2. Activation and integration with Metro Station

## Podium Facade - Integration of Services

**Figure 1. Ground Floor Plan, Elizabeth Street maximises active street frontages**

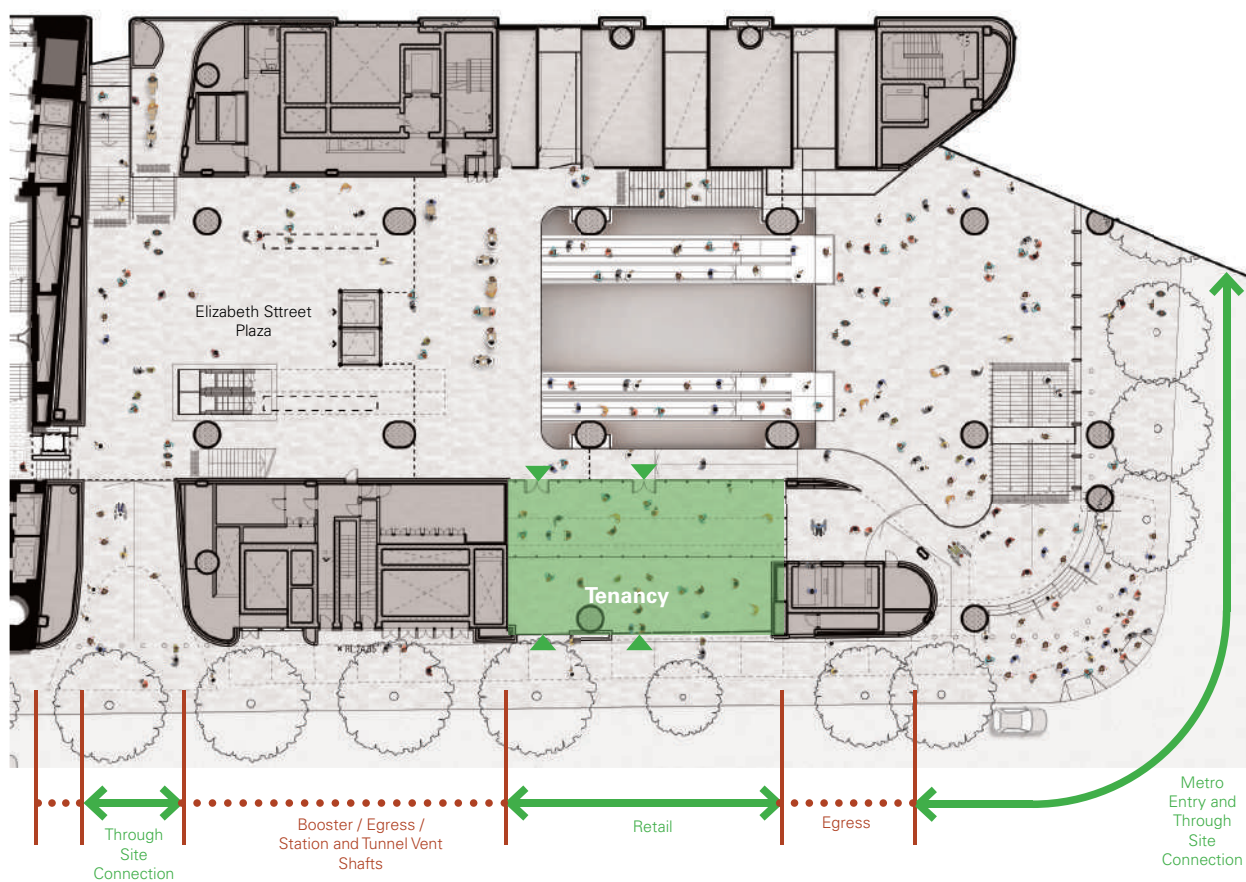
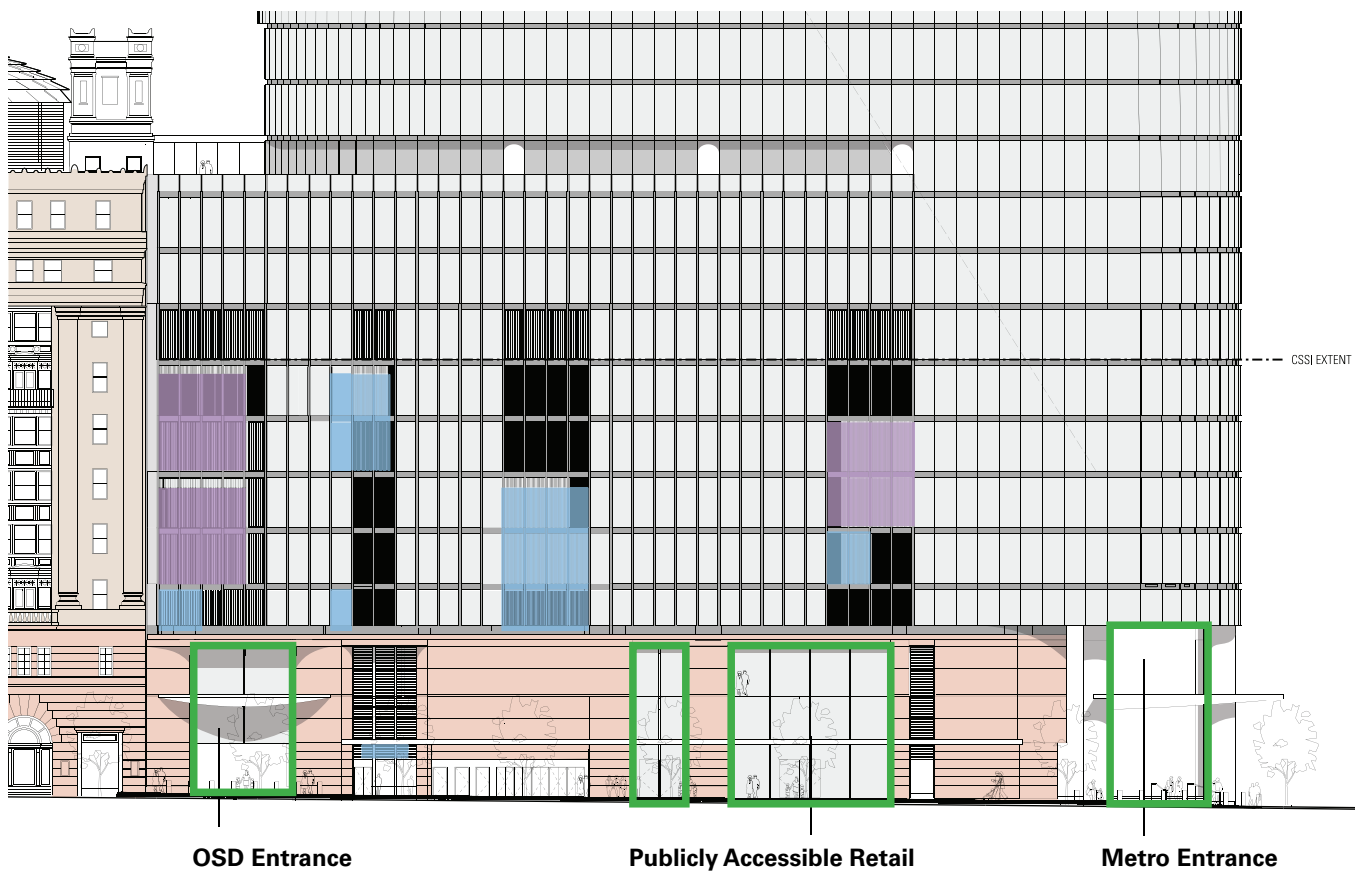
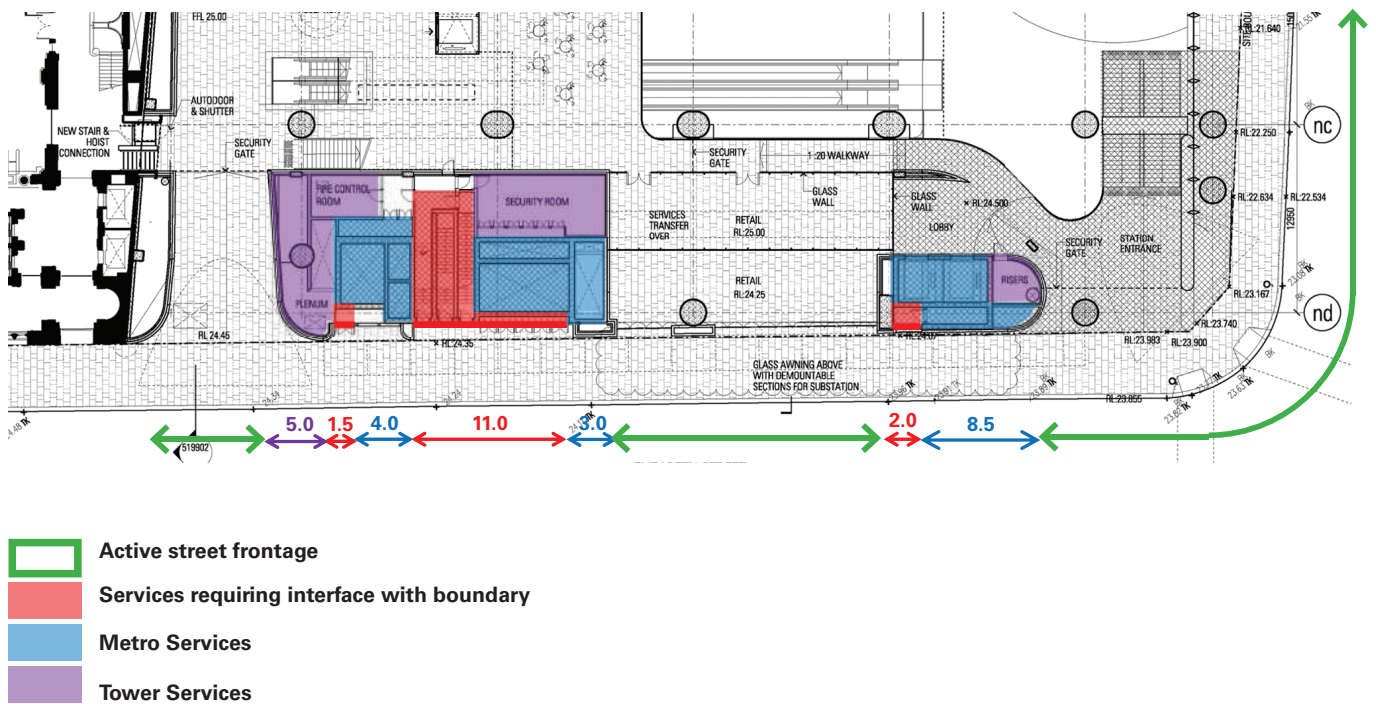
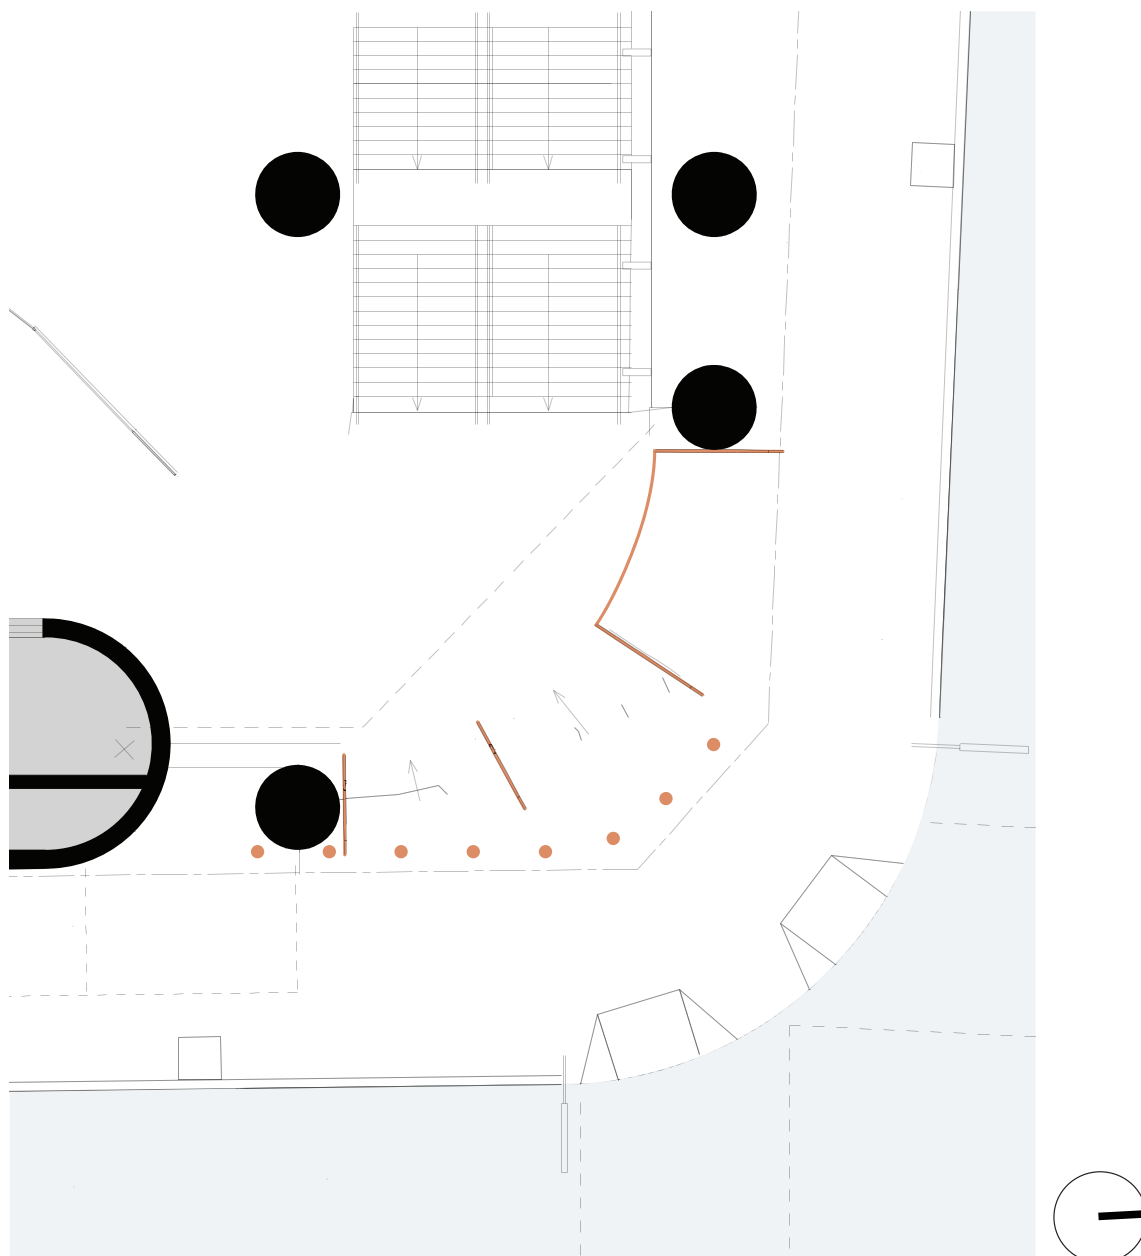
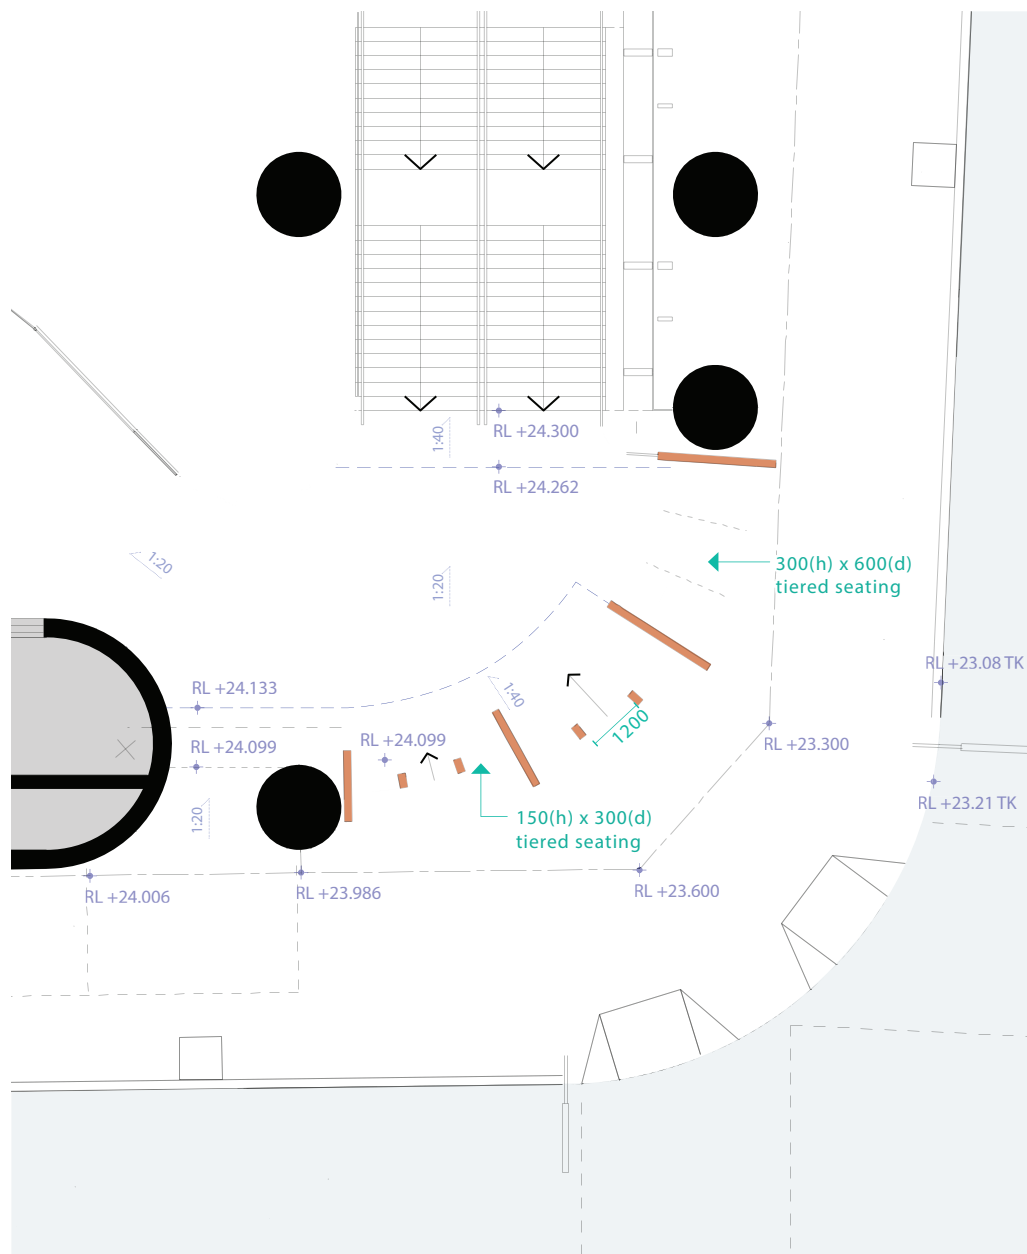
“The Elizabeth Street frontages of both buildings are seriously compromised by services and predominance of steps and ungainly ramps (at the intersections with Martin Place and Hunter Street). The City recommends that the floor levels be reviewed to provide grade entry from Elizabeth Street to station lifts and building lobbies.”

The design of the ground plane maximises street level activation. An integrated development approach has allowed essential station and tower services, including those requiring street level boundary locations, to be consolidated and minimised at ground level. (Fig.1). A significant retail tenancy is also created on Elizabeth Street. (Fig.1&4)

Ground levels comply with minimum requirements for flood and overland flow and these have been integrated logically into the metro entrances via a manipulation of levels and sensitive introduction of ramps and steps. Universally accessible points are provided along each boundary of the site and on grade retail activates the Elizabeth Street ground plane. (Fig.6&7).

The integrated development allows the consolidation of Metro services with North Tower services resulting in a coordinated approach which minimises intrusion of services into the public domain. With the priority to activate the streets and provide through-site connections, the space available for the large service ducts, fire exits and access lifts is very constrained. (Fig.2&3)

The scheme minimises the impact of Metro services on the public domain. Plant/BOH zones for tower and Metro are consolidated and primarily located below ground to minimise street presence. The scheme locates the service risers in the parts of the site that have the least value to the activation and amenity of the public domain. To allow for the inclusion of generously scaled spaces in the ground levels of the building, the Metro plant rooms and outlets are stacked vertically to minimise the footprint in the publically accessible lower levels. (Fig.2&3).

This approach also allows the exhaust outlets to be carefully concealed in the façade design, positioned well above the street. (Fig.5).

Integration of Hostile Vehicle Mitigation (HVM) bollards into the handrail design where possible to reduce on-street clutter and the integration of HVM bollards into the steps to terminate feathered steps at rational points to mitigate trip hazard risk. (Fig.6).

RLs identified in the design is based on a 2.5% cross-fall from top of kerbs. This is subject to detailed development and below-ground utilities survey information currently being undertaken. (Fig.7).

**Figure 1. North Facade signage zone**

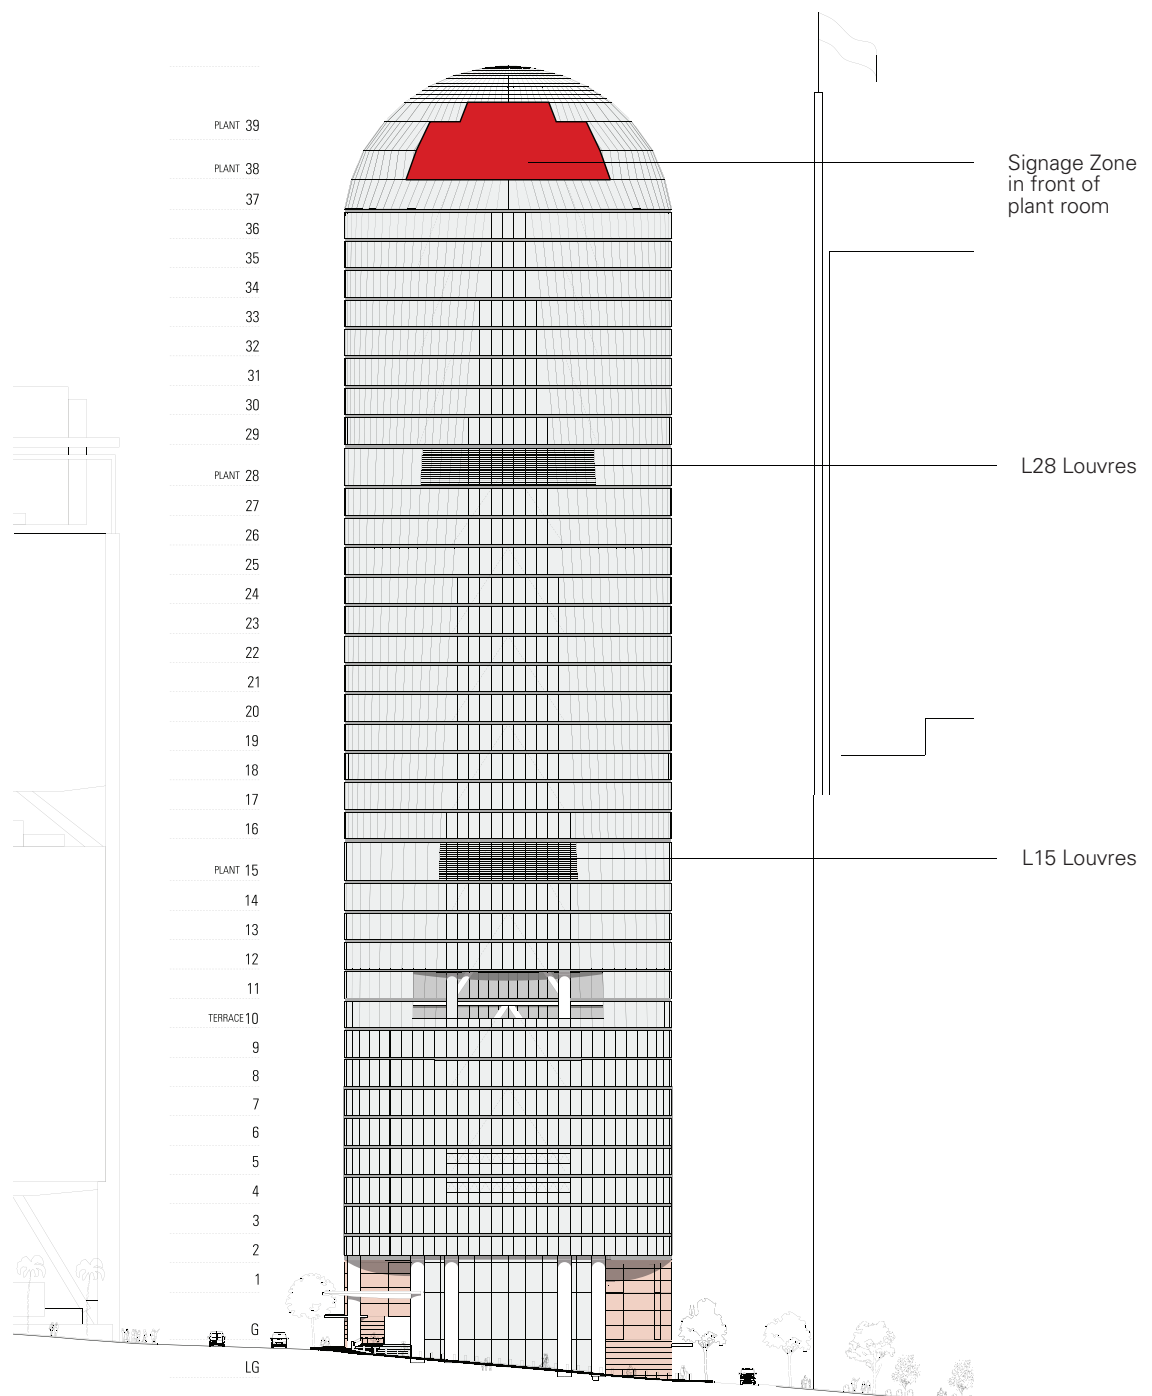
“Top of building signage zones should be limited to a maximum of two zones in accordance with Sydney Development Control Plan 2012. Sufficient details should be included in this application to ensure integration and compatibility with the architectural design, materials, finishes and colours of the building. The City strongly objects to the approval of the use of more than two top of building signage zones per building.”
